MEMORANDUM

Re: 603 E William Returning Sign Application

ANN ARBOR HISTORIC DISTRICT COMMISSION

ADDRESS: 603 E William Street, Application Number HDC20-157

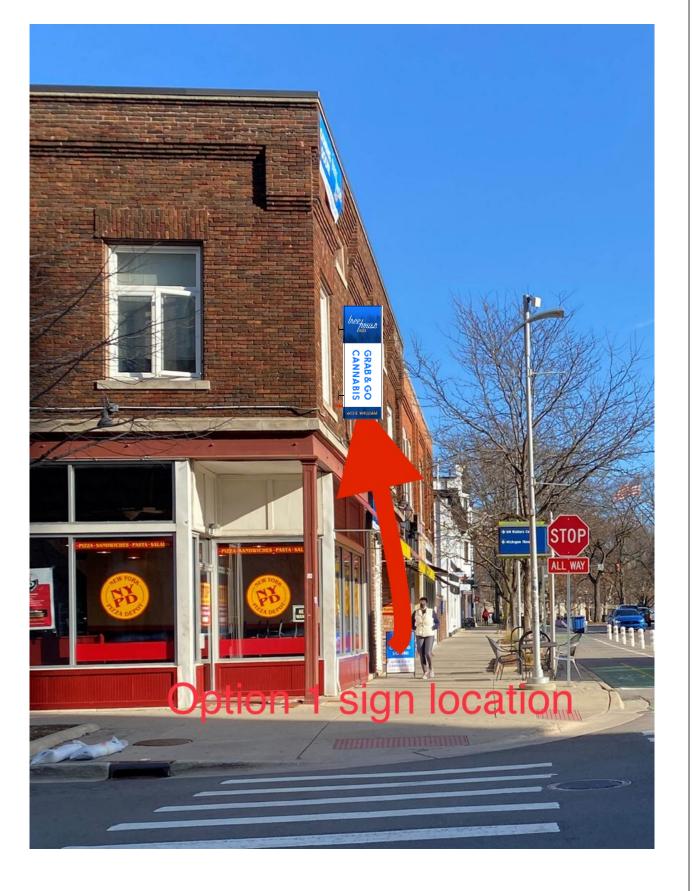
At the November 12, 2020 HDC meeting, a request for a blade sign on the corner of the building at this address was postponed and the applicant was asked to return with a smaller sign design. The new design has been reduced from $6' \times 3'$ to $6' \times 2'$, and the location has been changed to the front elevation between the second story windows. The applicant has been asked to provide an elevation drawing of the front of the building with the sign and the 2^{nd} story windows with dimensions.

I move that the Commission issue a certificate of appropriateness for the portion of the application at 603 E William Street, a contributing property in the East William Historic District, to install a second-floor blade sign mounted through mortar joints, as shown on revised drawings. The work is compatible in exterior design, arrangement, texture, material and relationship to the rest of the building and the surrounding area and meets the *Ann Arbor Historic District Design Guidelines* for storefronts and signs, and *The Secretary of the Interior's Standards for Rehabilitation* and *Guidelines for Rehabilitating Historic Buildings*, in particular, standards 1, 2 and 9 and the guidelines for storefronts and building site.
